RE: **Contract No. NB-630-000-006**
Administration Building Additions and Rnovations
Nice Bridge

ADDENDUM NO. 3

TITLE: Administration Building Addition and Renovation

FACILITY: Nice Bridge

NICE BRIDGE ADMINISTRATION BUILDING HVAC PROJECT
 ADDENDUM - I; DRAWING E-7; SKETCH-14

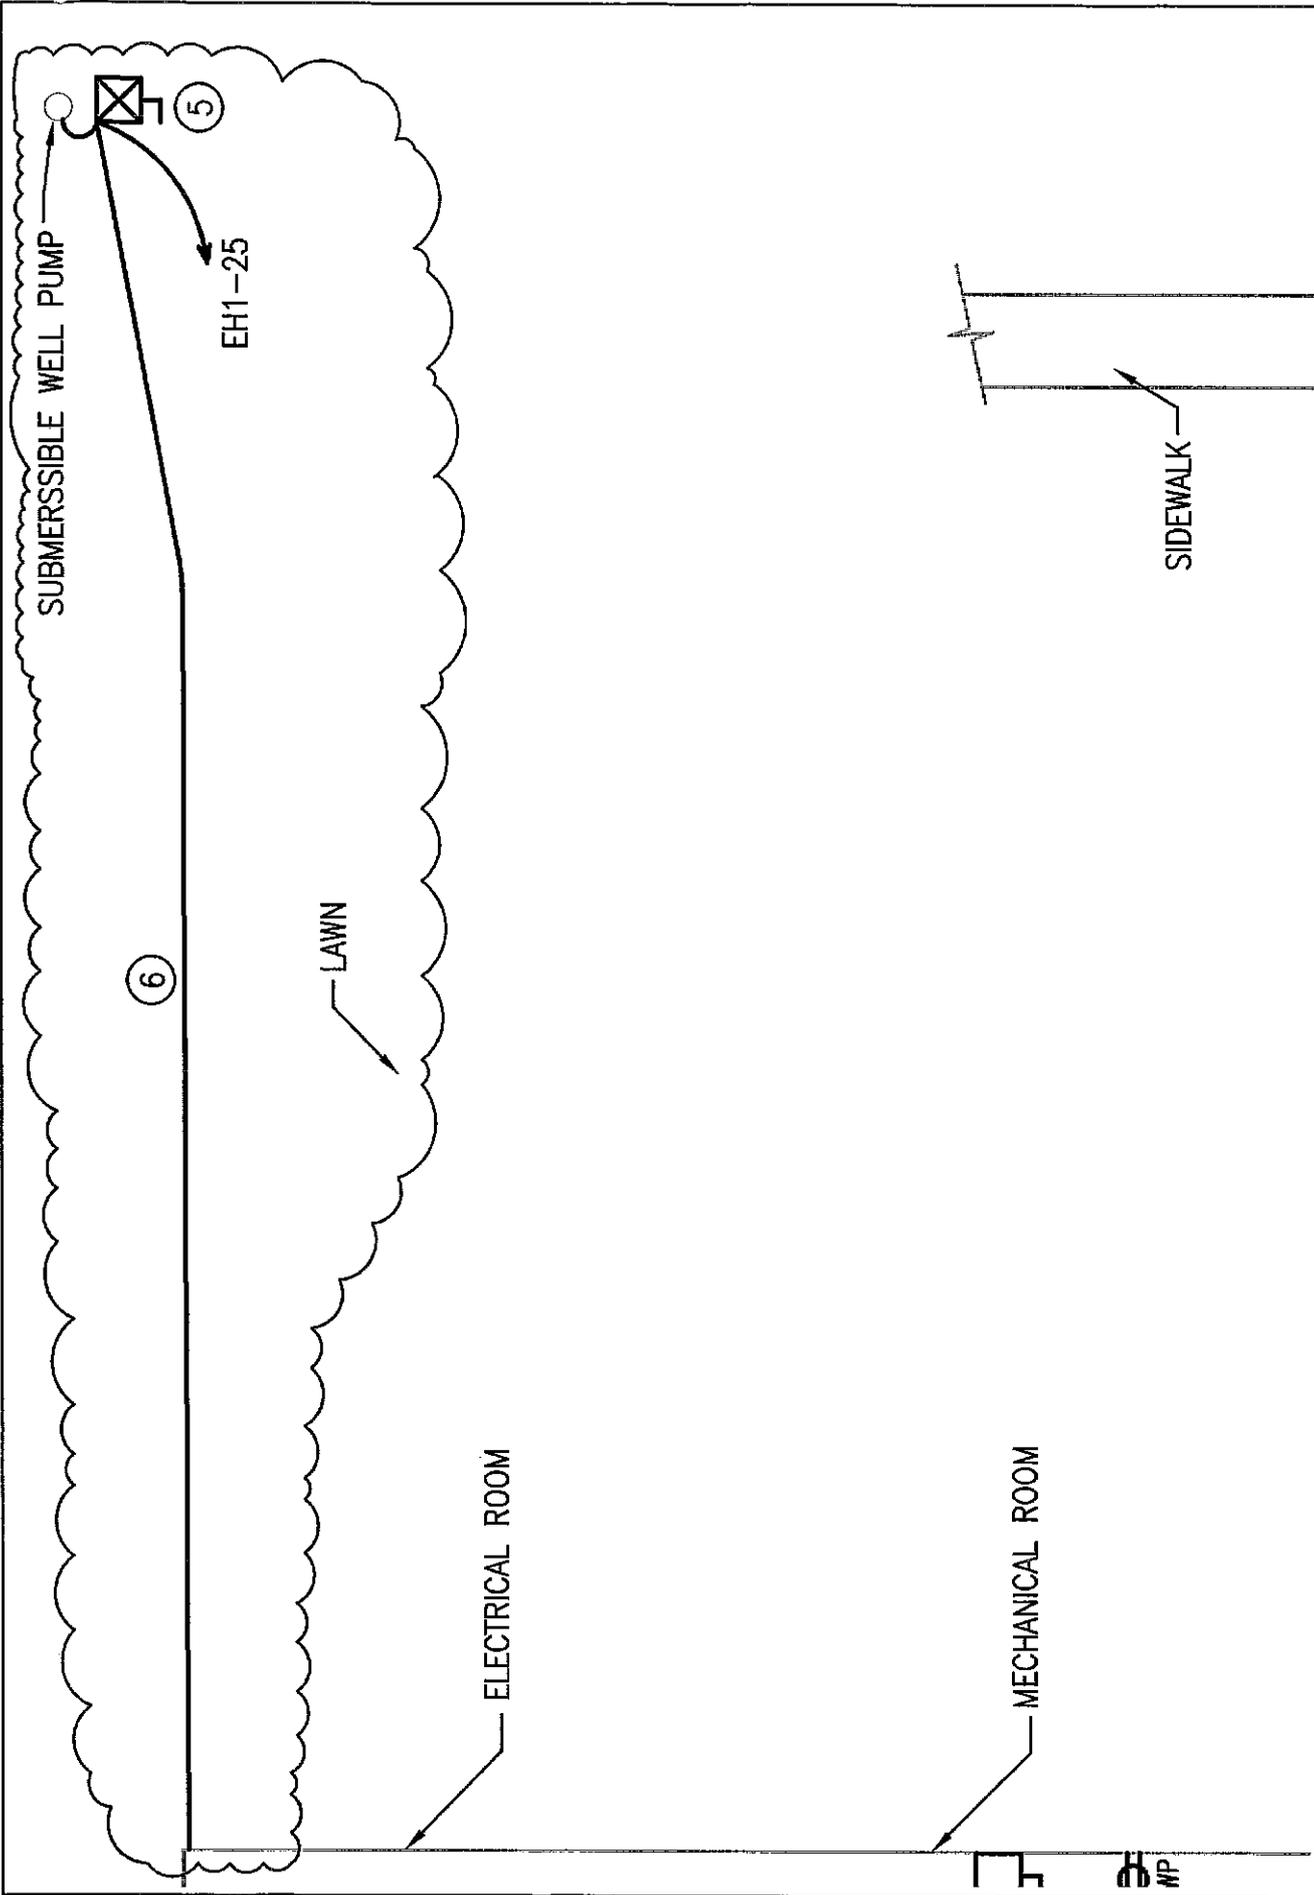
30. Re-route the direct buried conduit from submersible pump to panel EH1. The conduit will be direct buried 36” underground from submersible pump to the building & surface mounted inside the building. Refer Sketch 14 for new route.

WATER PUMP CONTROL SCHEMATICS

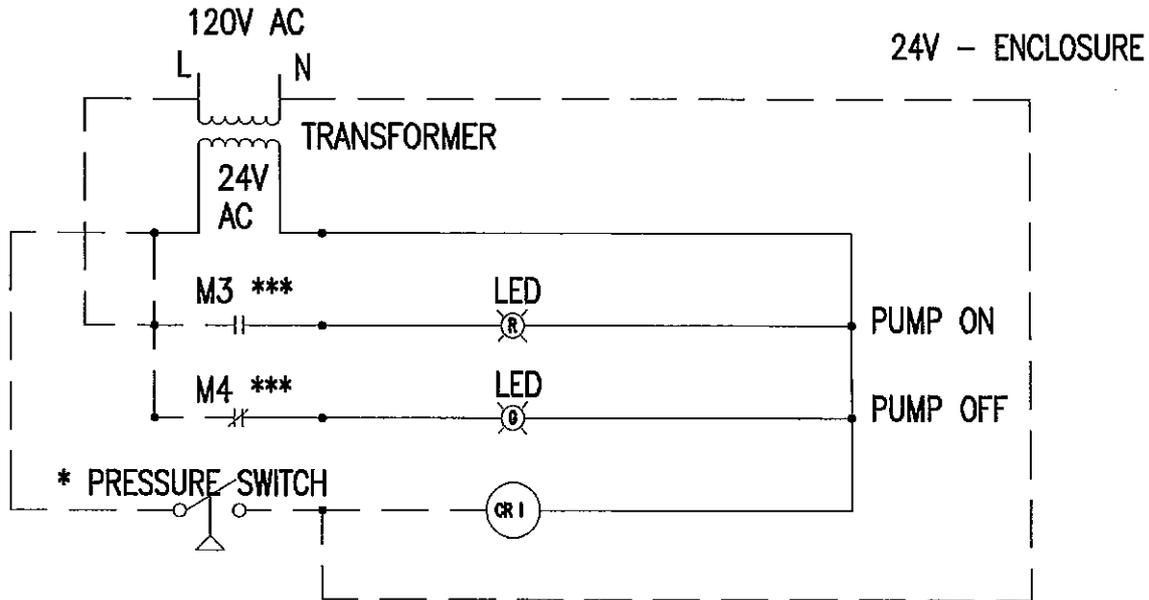
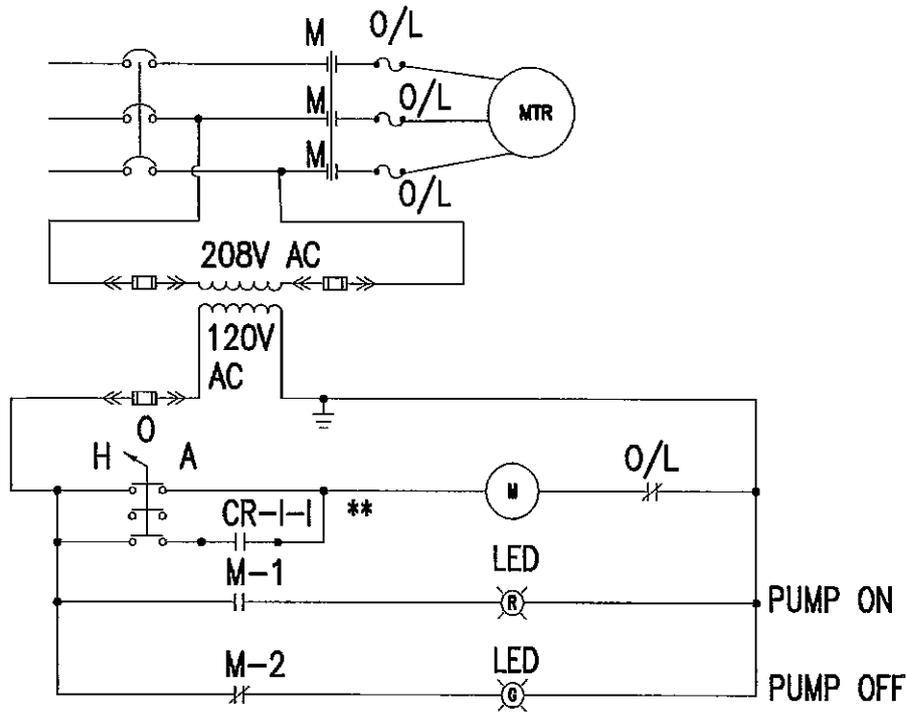
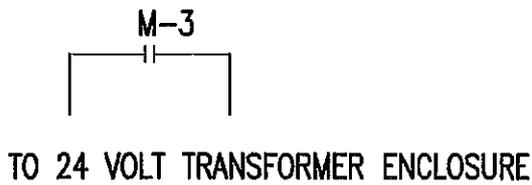
31. Provide all control wiring as per Sketch 15, 16, & 17 for submersible pump. Wiring inside the building shall be in EMT and use spare duct per note 6 on drawing E-7 for outside control wiring.

32. Provide 1P, 15A, 120V circuit breaker at available space in Panel EL1 located in Electrical Room & provide power pressure switch using 2 # 12 & #12G in ¾' conduit as required in sketches 15, 16 & 17..
